To: T10 Technical Committee  
 From: Rob Elliott, HP (elliott@hp.com)  
 Date: 2 May 2008  
 Subject: 08-126r1 SPC-4 SBC-3 SAS-2.1 Power condition enhancements

Revision 0 (6 March 2008) First revision  
 Revision 1 (2 May 2008) Incorporated feedback from March CAP WG.

Figure 220 — SA\_PC (SCSI application layer power condition) state machine for SAS [\[updated\]](#)

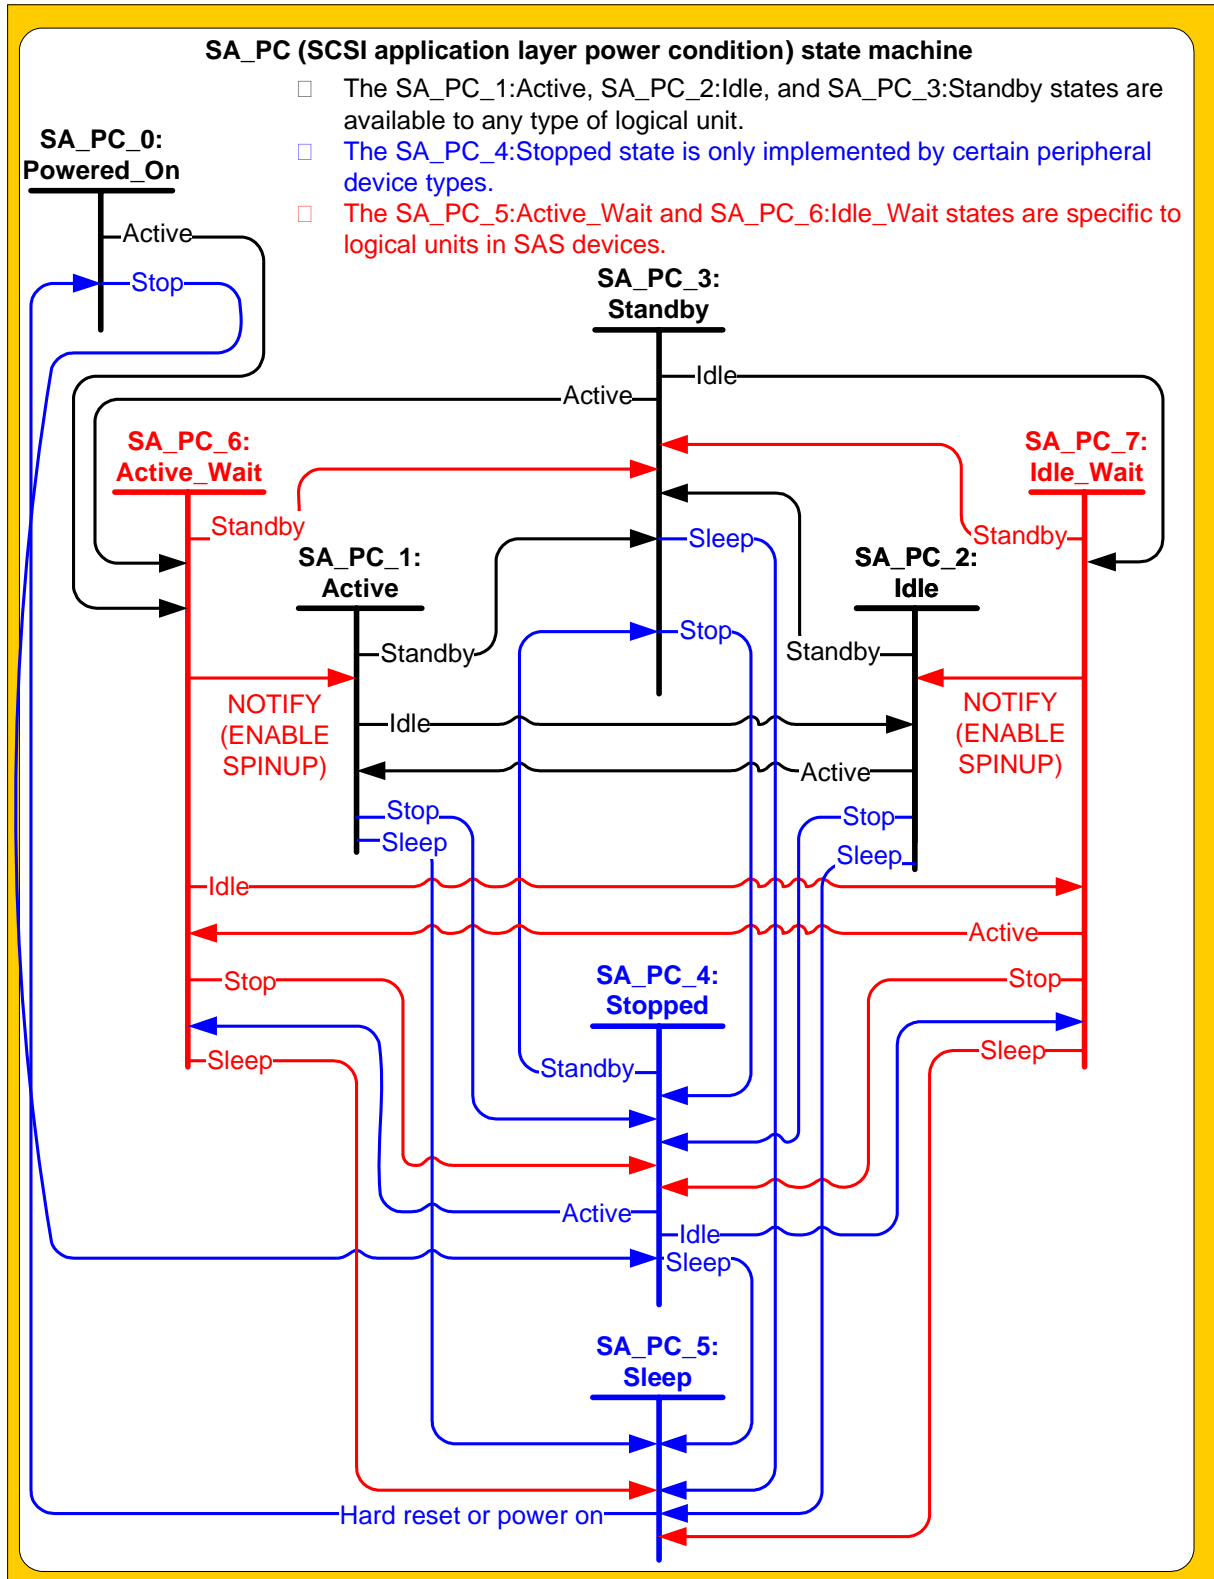
The SA\_PC (SCSI application layer power condition) state machine describes how the SAS target device processes logical unit power condition state change requests and NOTIFY (ENABLE SPINUP) if it is a SCSI target device.

If the device server processes a START STOP UNIT command (see SBC-3, [MMC-6, or RBC](#)) with the IMMED bit set to one, it may complete the command before completing the transition, if any, specified by the POWER CONDITION field and the START bit.
